128 McKinley

From: Scott Hanson
To: Goduti Building Company
Date: 3/5/2008 11:18:43 AM
Subject: Re: Diamond Cove

I wanted to give you a view of what we intend to do at this house on the parade ground at Diamond Cove. We have been hired to replace the columns, caps and bases. We intend to use a Tuscan style (8 " to match existing) fiberglass column for longevity purposes.

*see
has picture.*

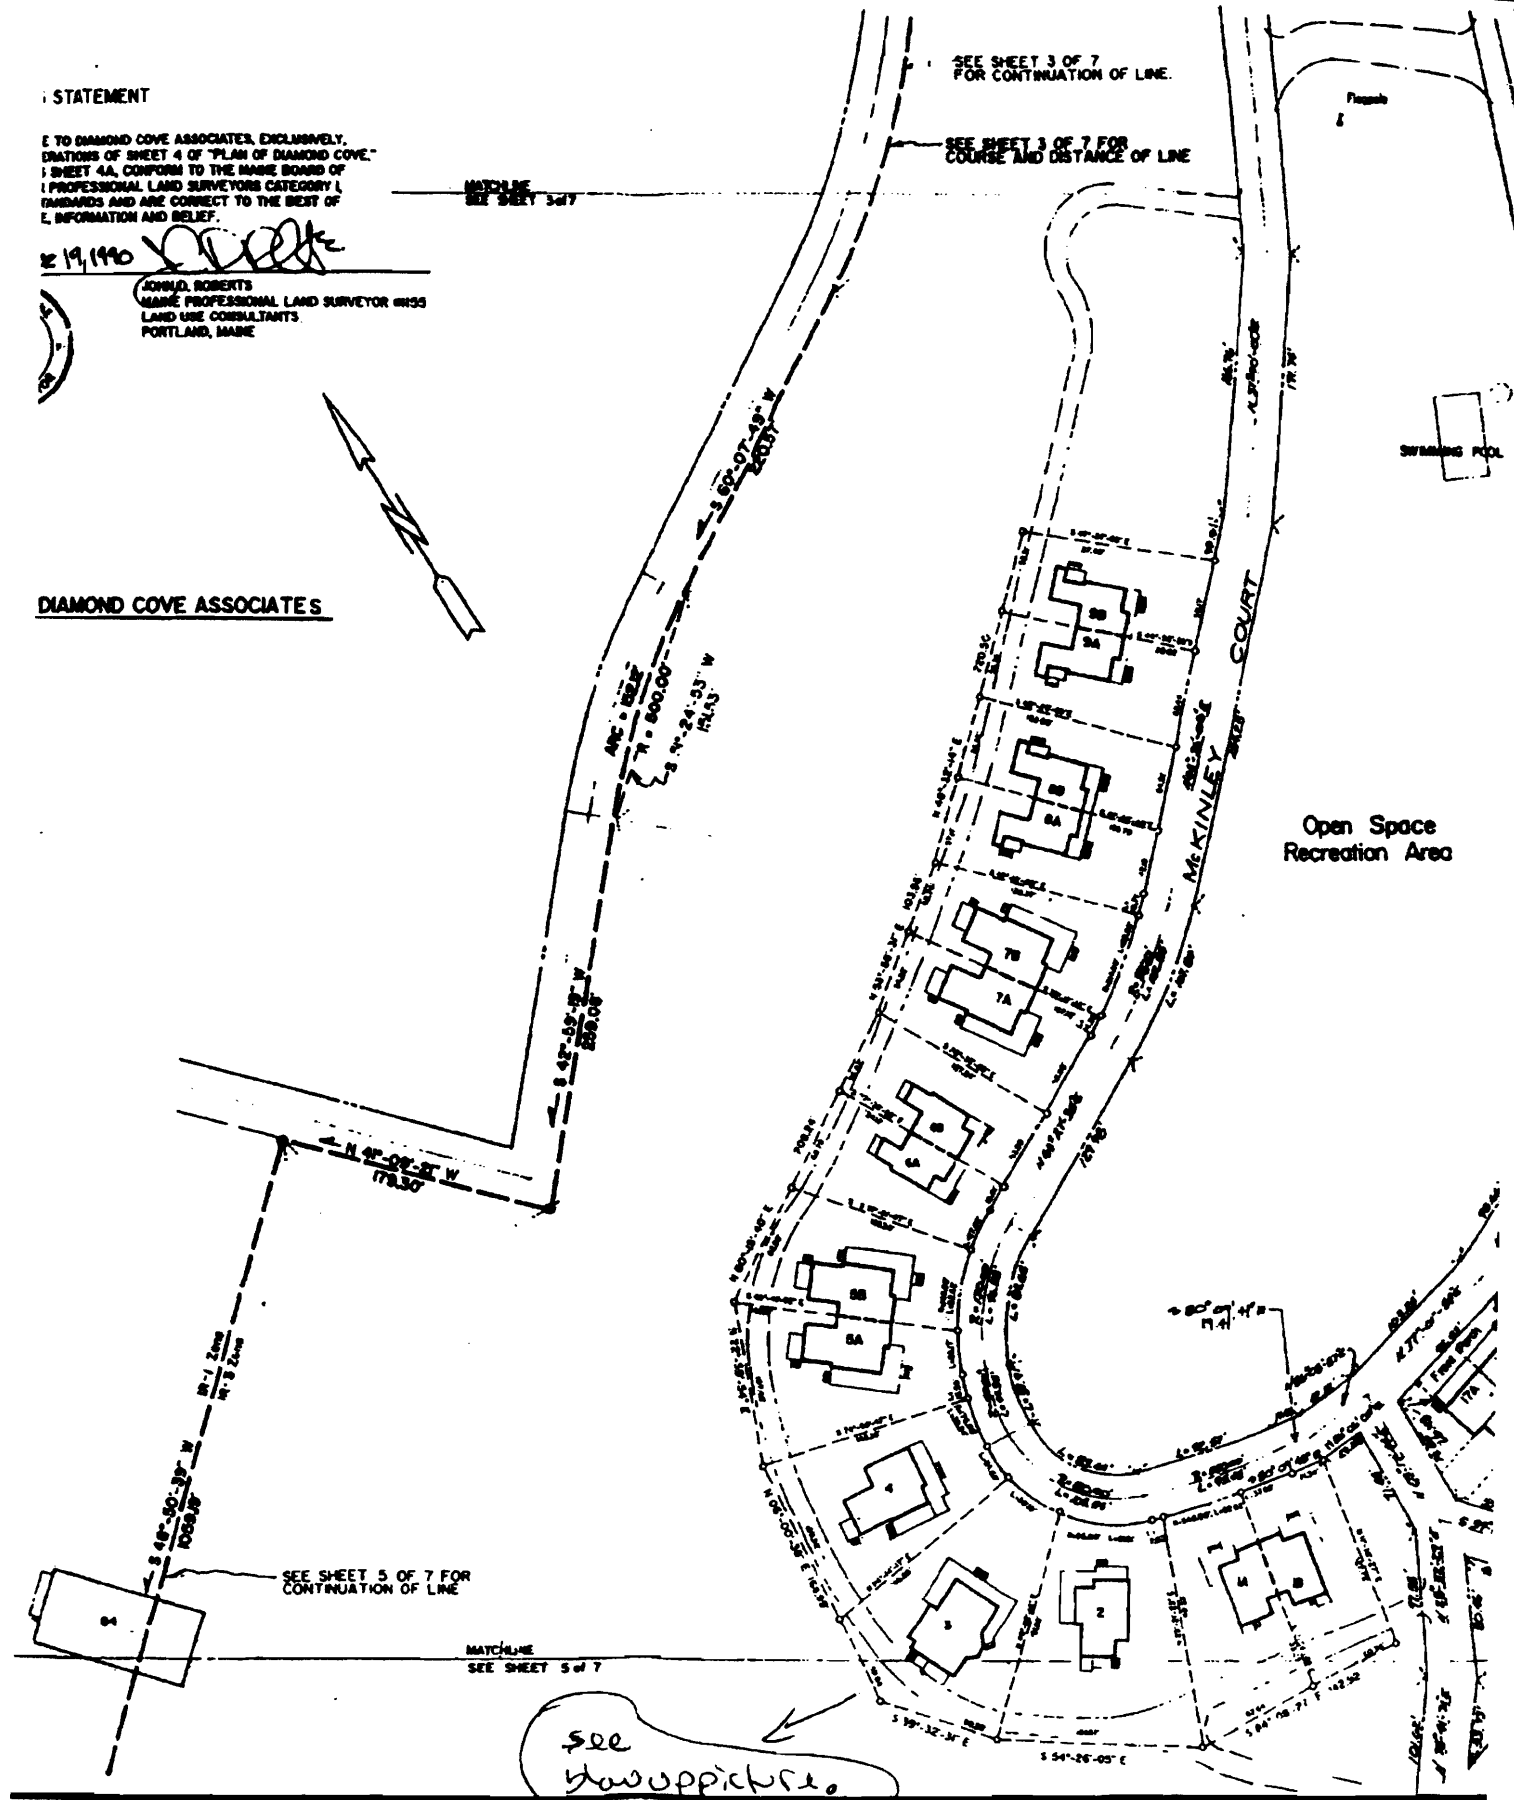
We are also replacing the bases, rails, and spindles to match existing details and profiles. The base boxes are to made of MDO plywood. The trimmings and spindles are to milled out of mahogany. The rails are to milled out of cedar. We are not replacing the steps and rails as those were done previously. The last item we are replacing is the 1x3, fir, tongue and groove deck surface.

I have sent this description to Deb. We intend to leave the rail height, balluster size and spacing and column location all the same for historic reasons. We are not doing the stairs as they are okay. We are not changing any spans nor are we performing any framing. All of that is intact and adequate so I don't think I have to provide you with any framing/span details.

I am quite sure the rail height is ^{current} less than 36" and that the space between balusters ^{is less} ~~may be a little more~~ than four inches.

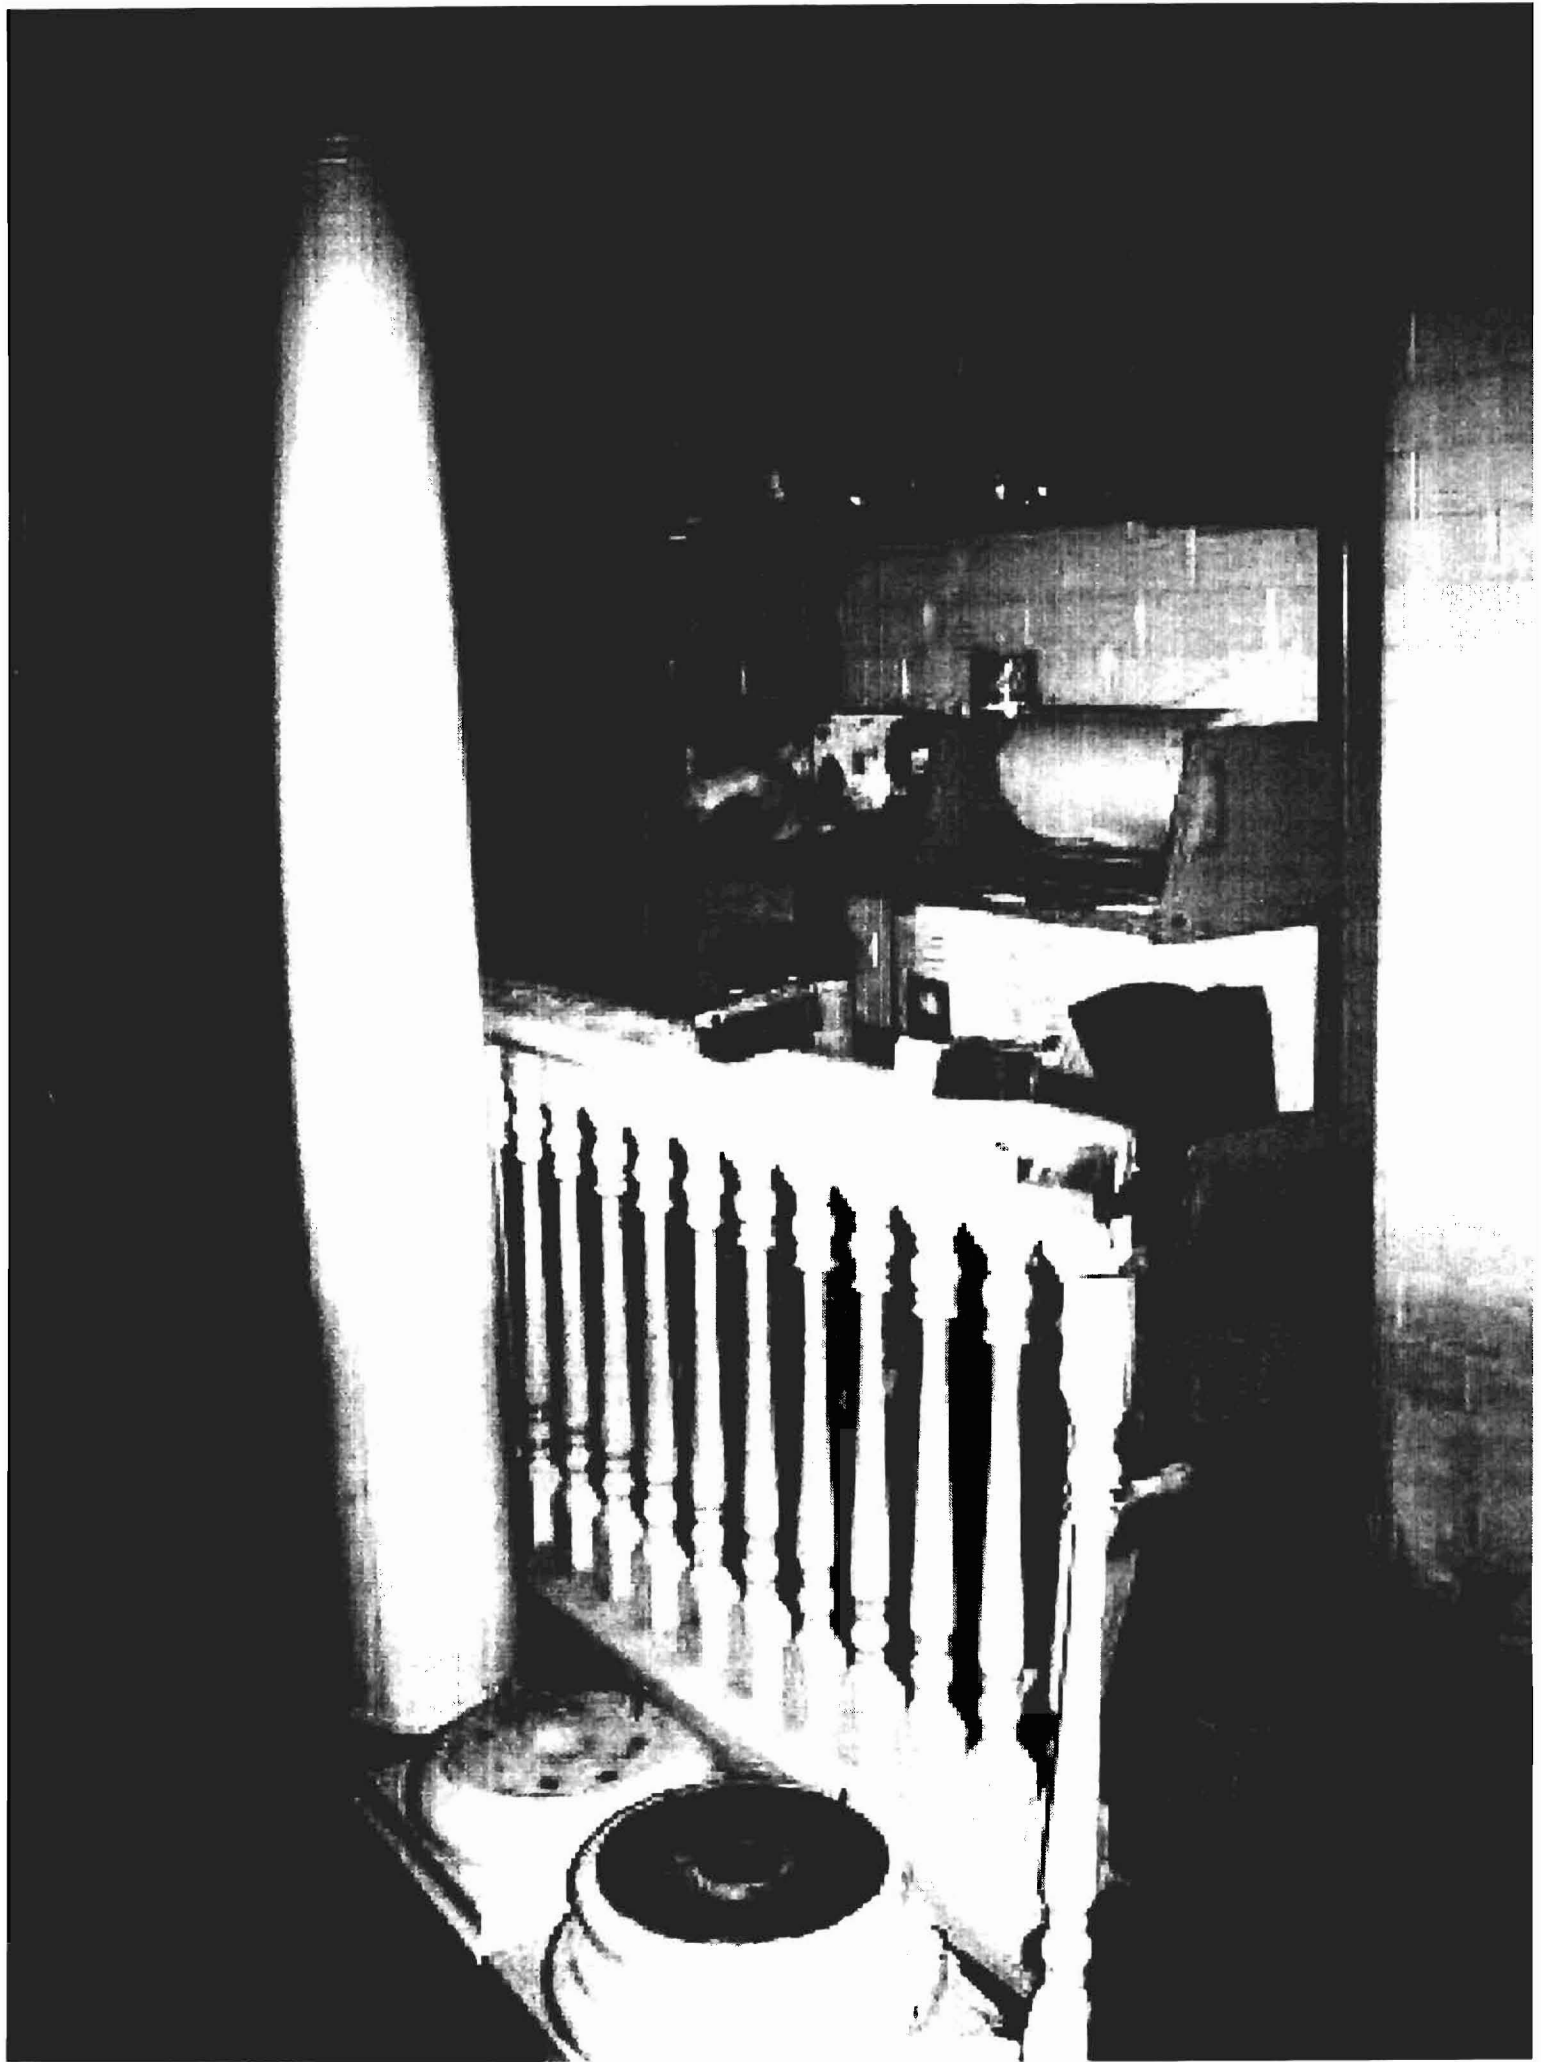
We will be matching the columns in either the wood or fiberglass. I will likely be having the base and cap done here and they will have these as templates. Now that you have the photo, what happens to the permit process?

> I think I indicated before that we are open to the possibility of
> fiberglass columns if you can find a dead-on match for the wood
> originals. We'll need enough information to compare them "side by
> side". A photo of an original with dimensions noted and a
> manufacturer's cut sheet with dimensions for the proposed replacement
> would do the trick. Of course the base and capital would need to match
> as well.

Typically we do not sign off on a permit until we have a cut sheet or drawing to document that the replacement will be an exact match for the original. I know you are anxious to get this approved and underway so what I will do is approve it with a condition that the new wood or fiberglass columns be an exact match to the originals and that once you have determined which you'll be using, you will give us a cut sheet (for fiberglass) or shop drawing (for wood) of the replacement to have the completed documentation for the file.
